# HISTORIC CONSERVATION BOARD AGENDA

Monday, September 11, 2017 at 3:00 pm

## APPLICATION FOR CERTIFICATE OF APPROPRIATENESS HISTORIC CONSERVATION BOARD PUBLIC HEARING STAFF REPORT

APPLICATION #: COA2017053  
APPLICANT: Drawing Department  
OWNER: 9487 Dry Fork Rd LLC  
ADDRESS: **1429 Walnut Street**  
PARCELS: 080-0001-0082  
ZONING: CN-P  
OVERLAYS: Over-the-Rhine Historic District  
COMMUNITY: Over-the-Rhine  
REPORT DATE: August 31, 2017  
HEARING DATE: September 11, 2017  
STAFF REVIEW: Beth Johnson Urban Conservator

WICHMAN GUNTER ARCHITECTS, INC.  
810 PLUM STREET / CINCINNATI, OHIO 45202 / (513) 241-9933

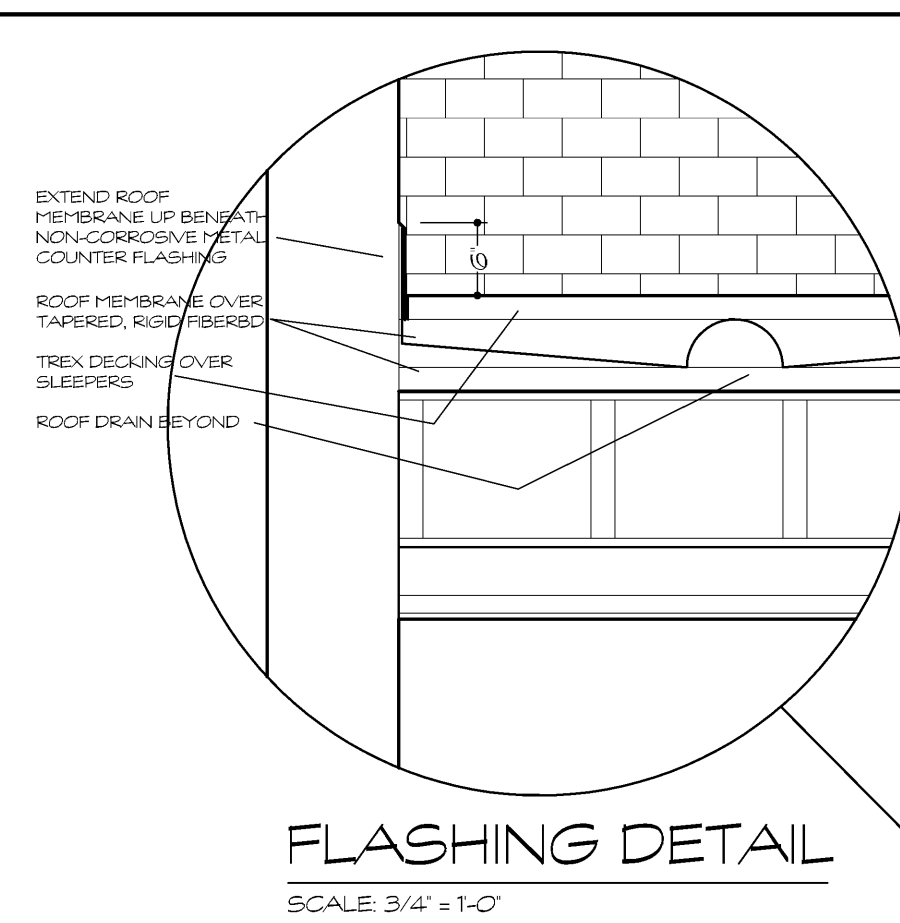
*We have often seen and permitted dormers of the rear of buildings in order to increase the height in the attic to provide for living space. While this changes the roof line, these changes are not visible from the primary street or are inconspicuously placed. Staff does not feel this is the case with the front dormer. Staff is supportive of the rear dormer as it won't be visible from Clifton and it isn't on the primary façade. This dormer will be visible from both Lang Street and at the intersection of Land and McMicken, but it will not detract from the architecture.*

*Staff is sympathetic to the stated economics issues of the project; however staff can not recommend that this portion of the project meets the Over-the-Rhine Historic Conservation Guidelines and does not feel that enough evidence has been submitted to prove an economic hardship. The applicants have submitted written testimony regarding the feasibility; however no number comparisons or floor plan studies were submitted for staff to review the economic viability of the project. For example, why can't the project support 2- 2 story units rather than just 1 and why can't the study be in the front of the*

*building and the bedroom in the rear. Studies are often smaller rooms. A minimum bathroom size is 6 ft by 6 ft and this could potentially be at the corner of the rear room and that would still provide a sizeable bedroom at over 10.5x10.5. The removal of the bathroom from the front would provide a still sizeable study.*

*Another option would be to retain the density at 7 units it to make the entire 4<sup>th</sup> floor one unit and keep the same floor plans on floors 1-3. This would allow for the elimination of hallways and the need for additional stairwell which would add additional square footage.*

**A.) TABLE** a Certificate of Appropriateness for 203-205 E Clifton Ave per plans submitted by Wichman Gunther Architects dates 6/15/2017 in order for the applicants to either remove the dormer or provide more substantial evidence of an economic hardship.
